STATE OF HAWAII
DEPARTMENT OF TRANSPORTATION
HIGHWAYS DIVISION

ROADWAY PLANS

FARRINGTON HIGHWAY RESURFACING

Federal Aid Project No. STP-093-1(026)

SHEET No. 1 OF 14 SHEETS

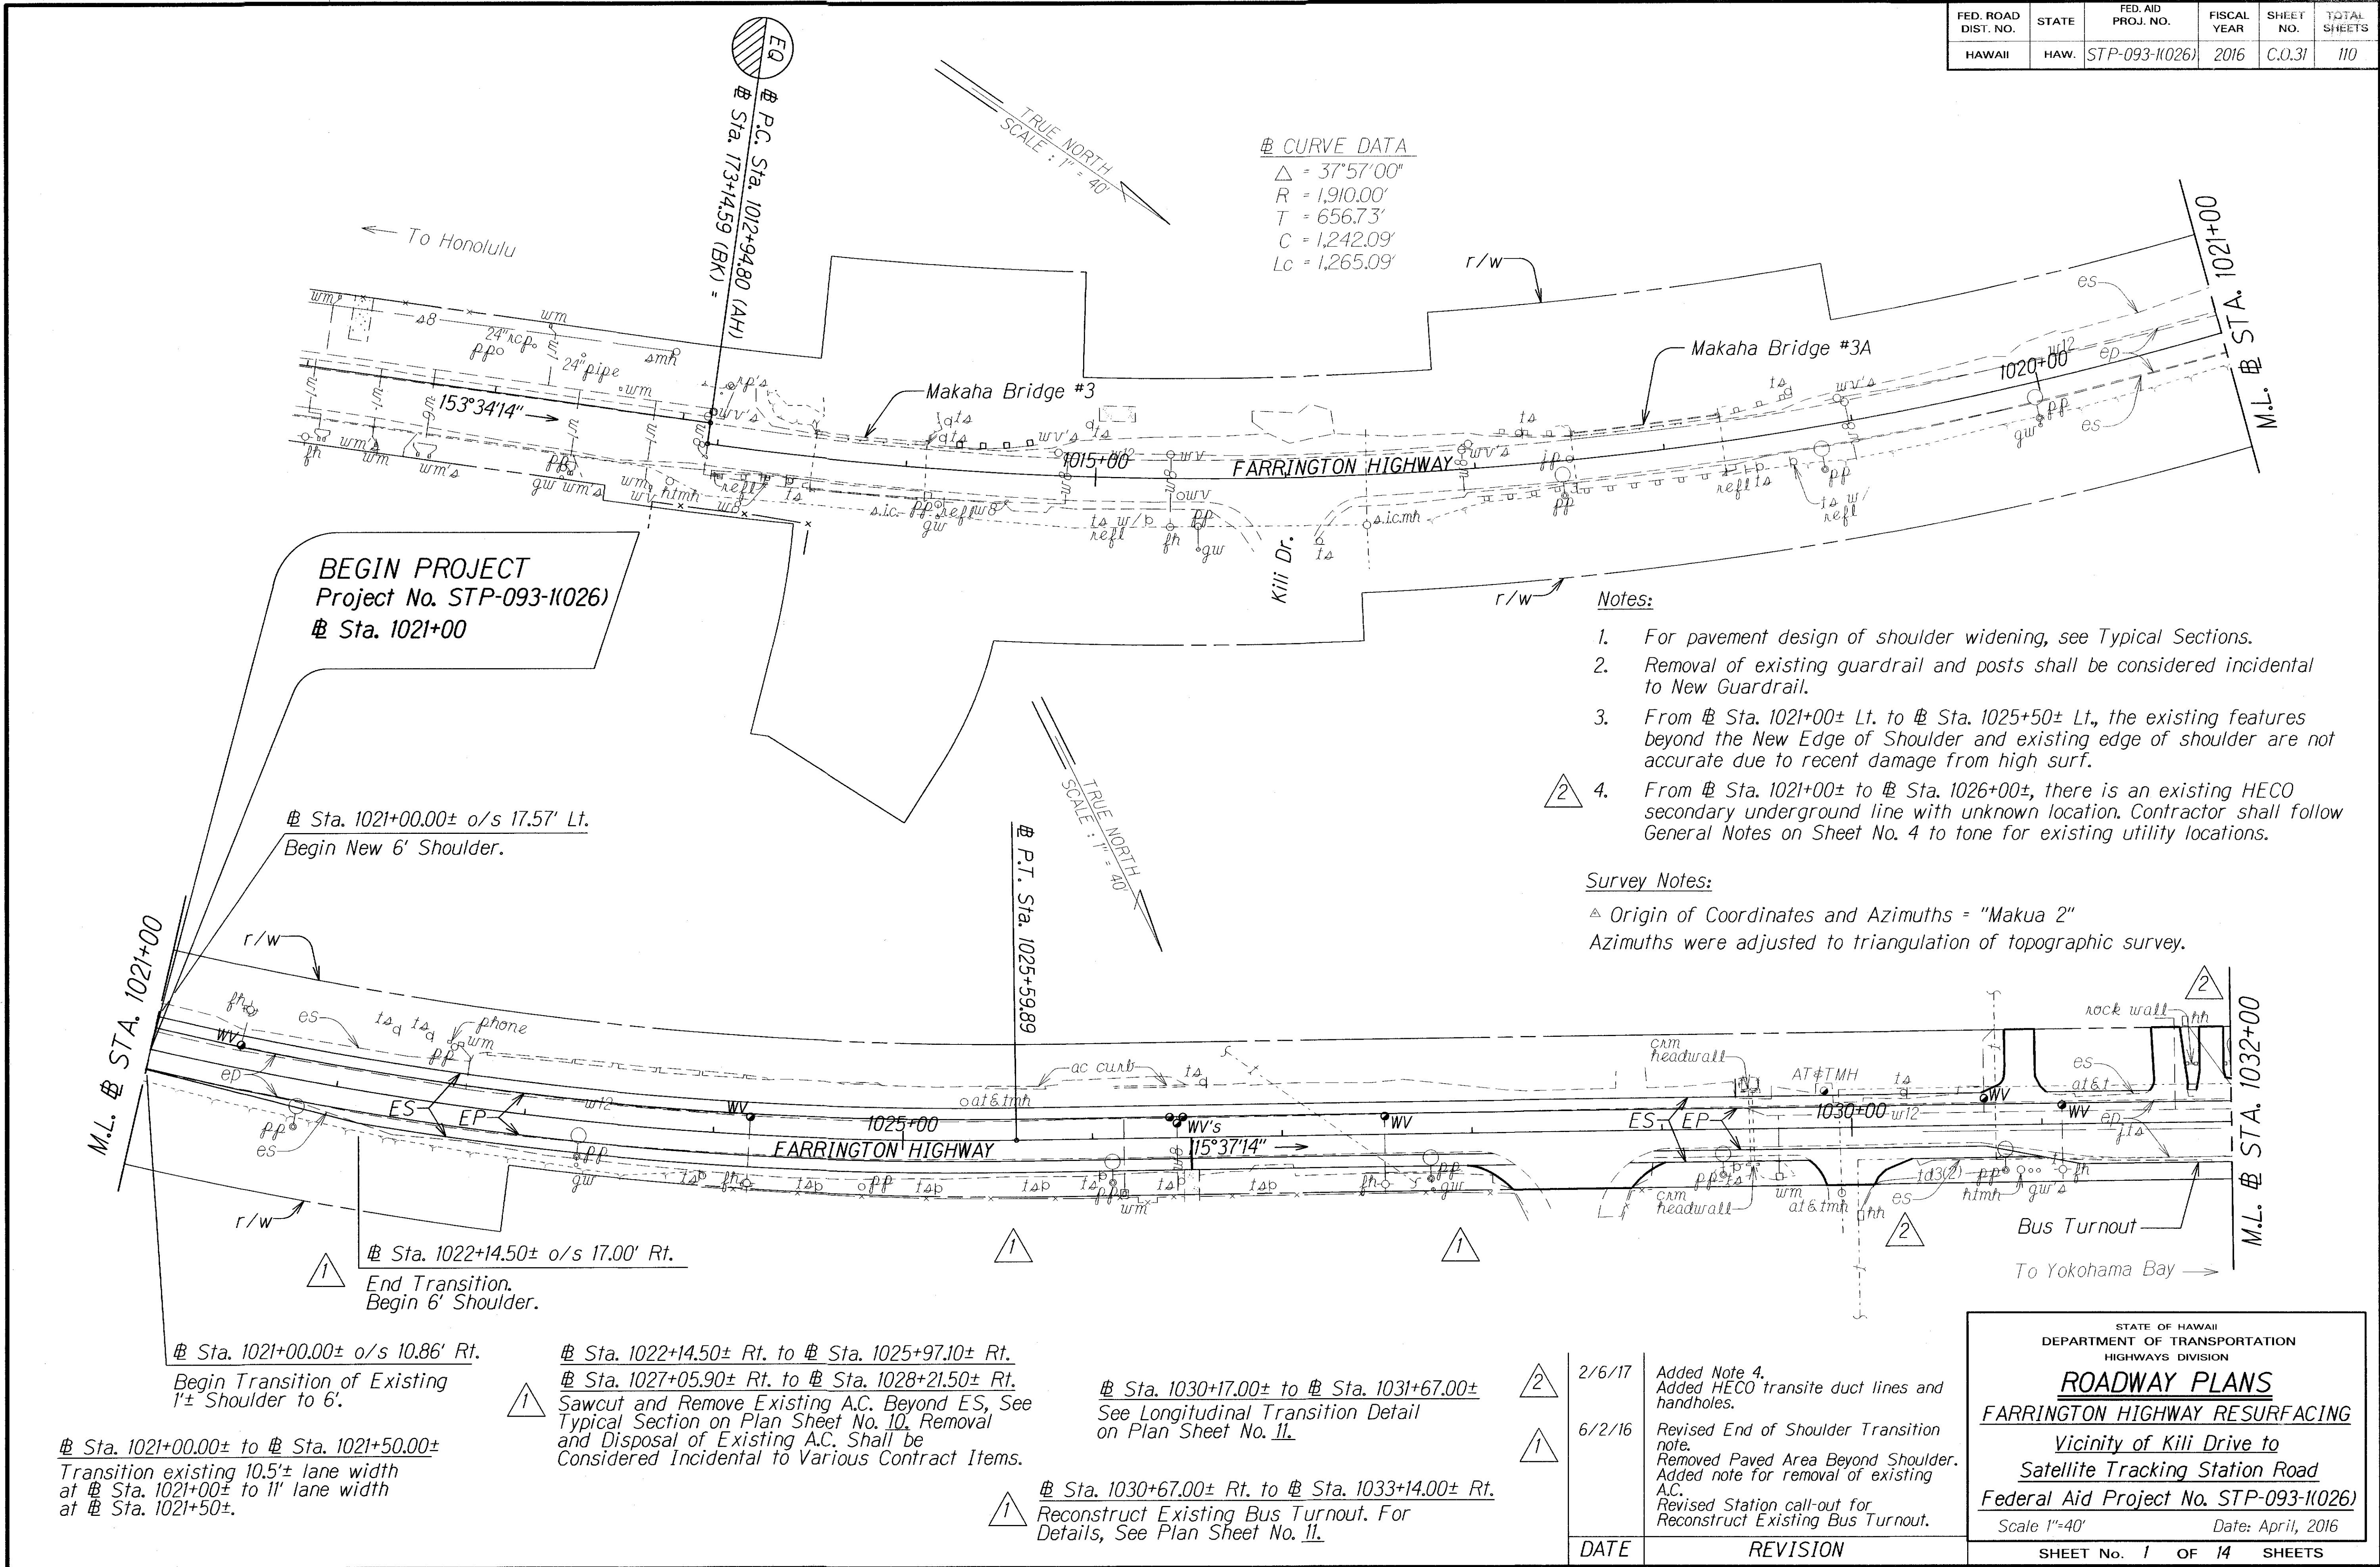
Added Note 4.
Added HECO transite duct lines and handholes.

Revised End of Shoulder Transition note.
Removed Paved Area Beyond Shoulder.
Added note for removal of existing A.C.
Revised Station call-out for Reconstruct Existing Bus Turnout.

STATE OF HAWAII
DEPARTMENT OF TRANSPORTATION
HIGHWAYS DIVISION
ROADWAY PLANS
FARRINGTON HIGHWAY RESURFACING
Vicinity of Kili Drive to
Satellite Tracking Station Road
Federal Aid Project No. STP-093-1(026)
Scale 1"=40' Date: April, 2016
SHEET No. 2 OF 14 SHEETS

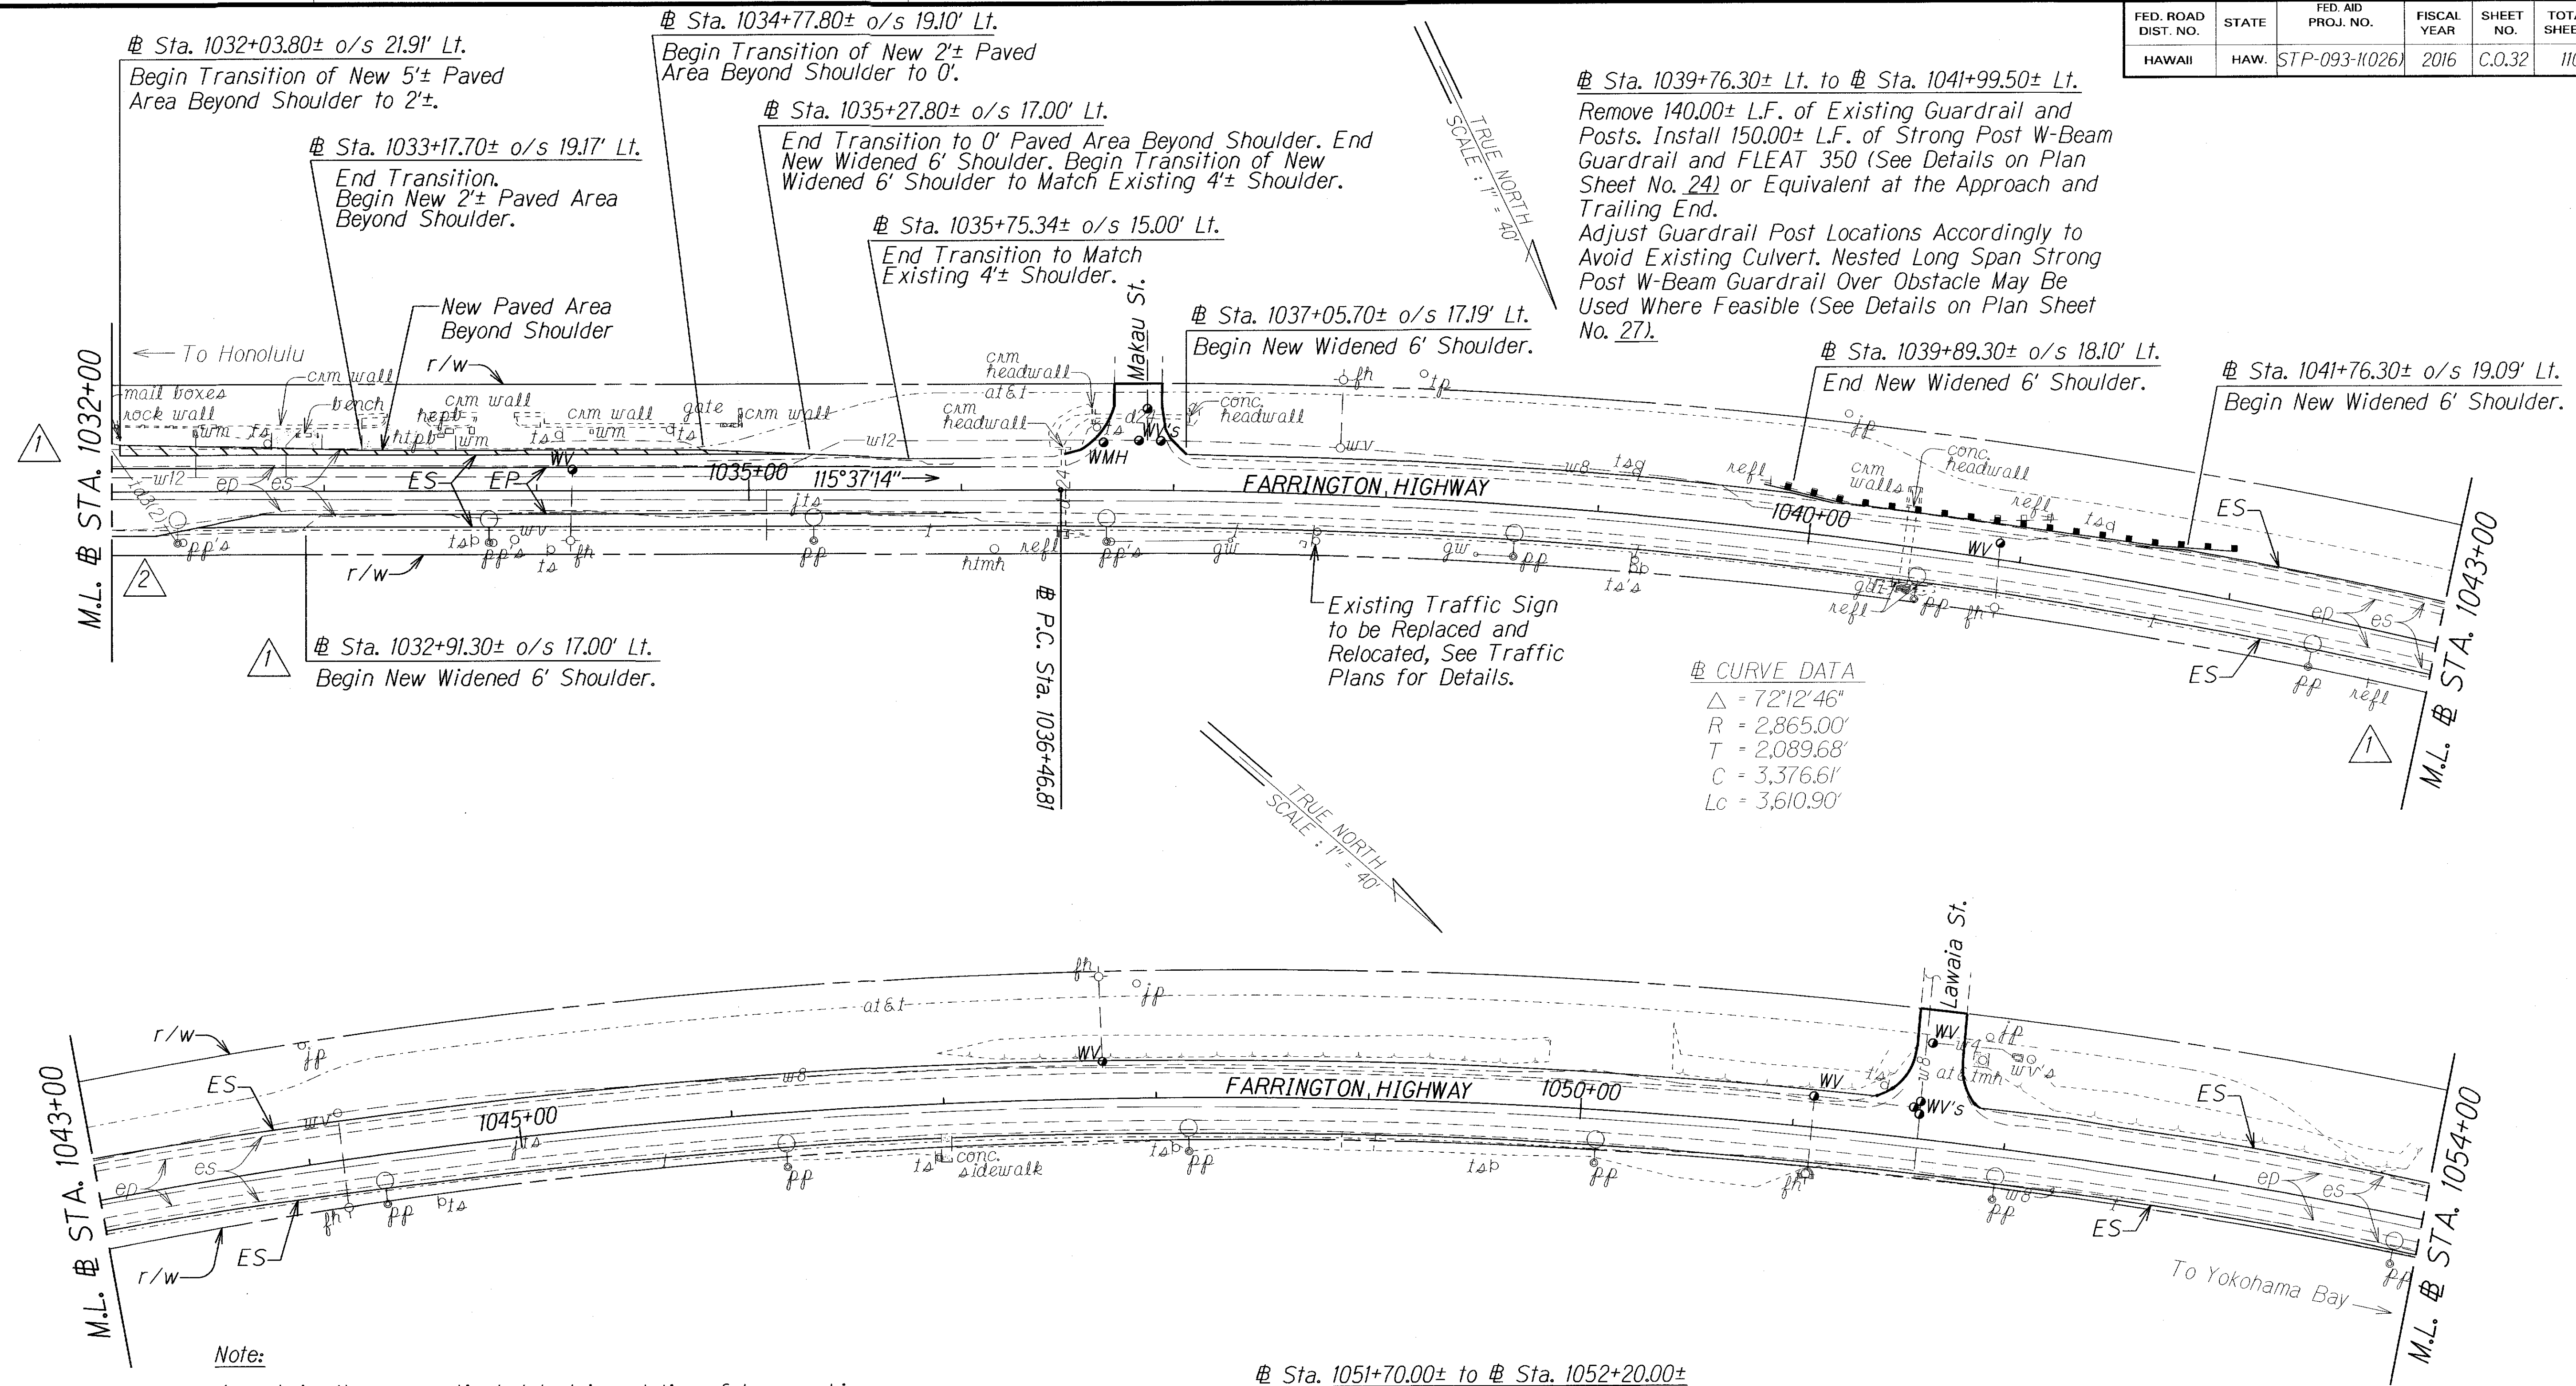
DATE	REVISION
2/6/17	Added HECO transite duct line. Added Note 5.
6/2/16	Changed hatch for New Paved Area Beyond Shoulder. Added note to begin widened shoulder. Revised es arrow to point to correct line.

STATE OF HAWAII
 DEPARTMENT OF TRANSPORTATION
 HIGHWAYS DIVISION
ROADWAY PLANS
FARRINGTON HIGHWAY RESURFACING
 Vicinity of Kili Drive to
 Satellite Tracking Station Road
 Federal Aid Project No. STP-093-11026
 Scale 1"=40' Date: April, 2016
 SHEET No. 4 OF 14 SHEETS

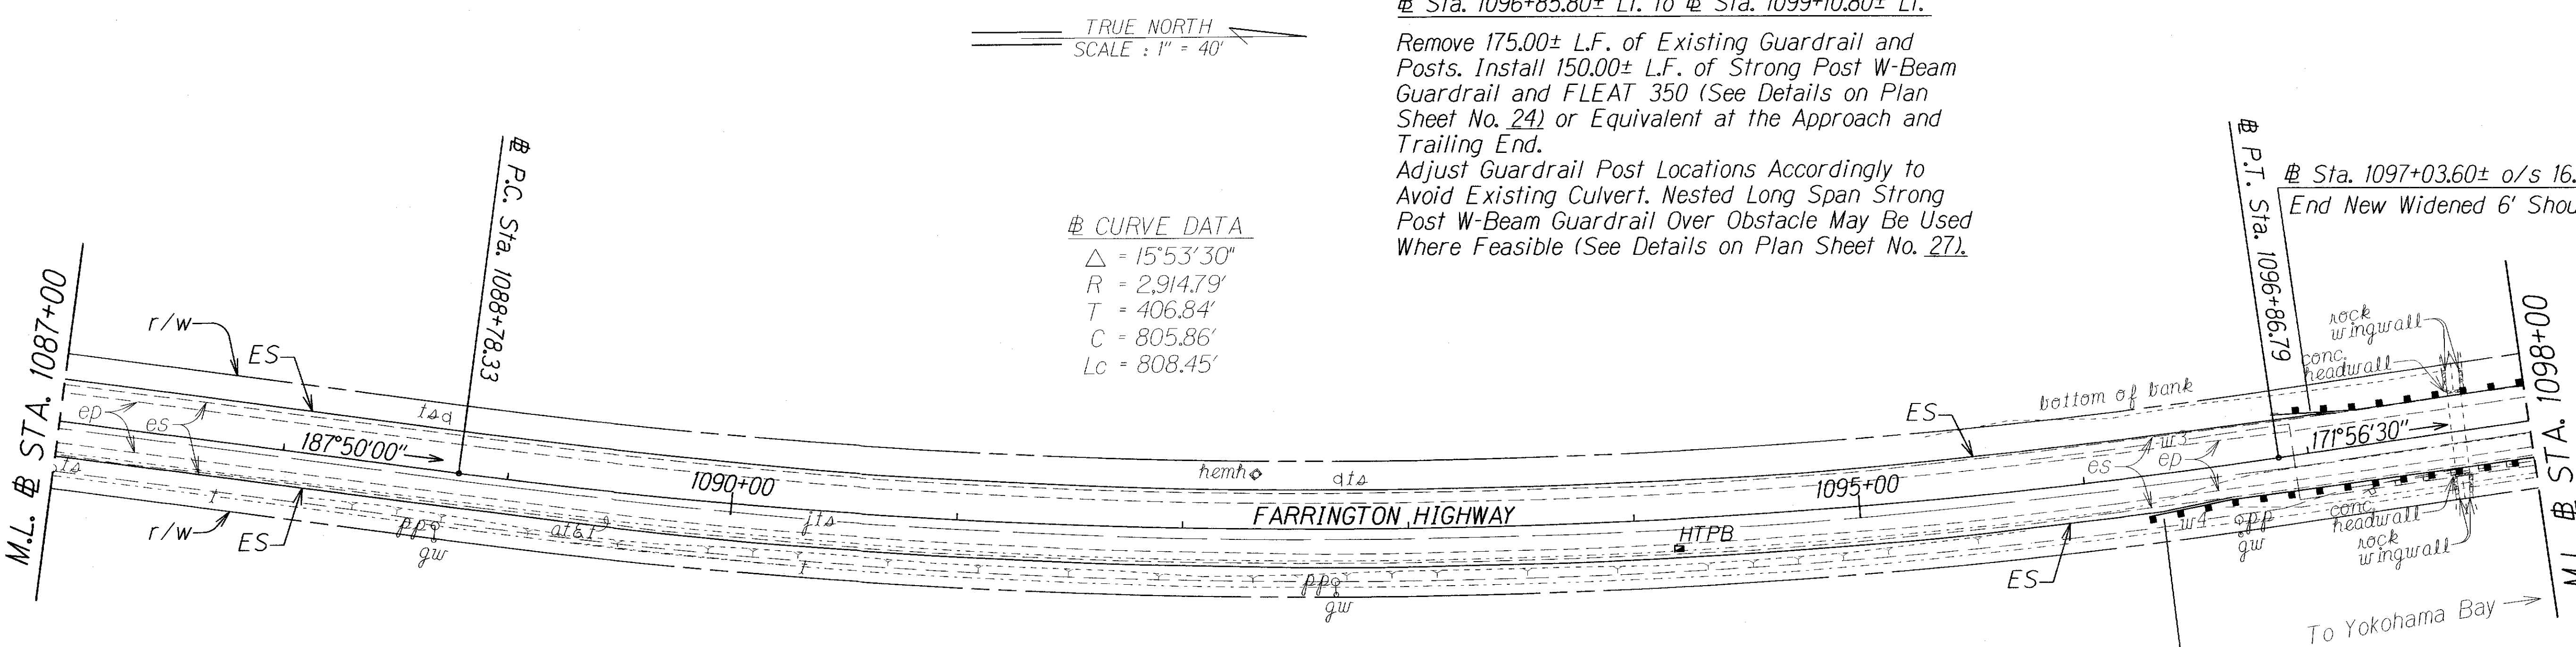
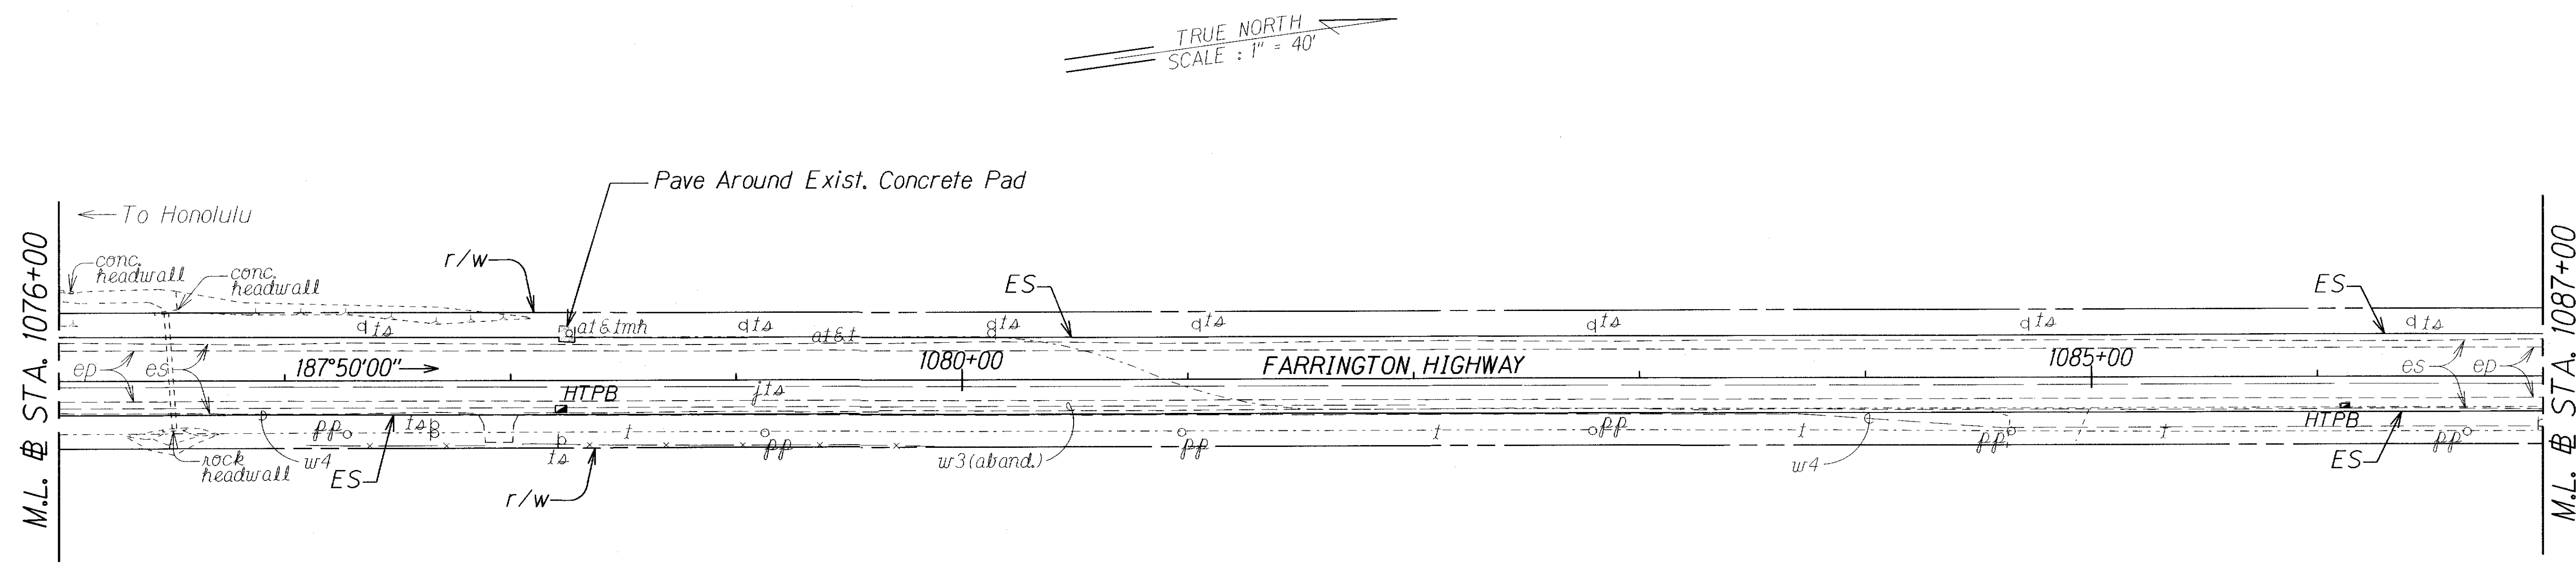
1. Removal and disposal of existing guardrail and posts shall be considered incidental to New Guardrail.
2. From # Sta. 1082+00± to # Sta. 1085+00±, there is an existing HECO secondary underground line with unknown location. Contractor shall follow General Notes on Sheet No. 4 to tone for existing utility locations.

2/6/17 Added Note 2.
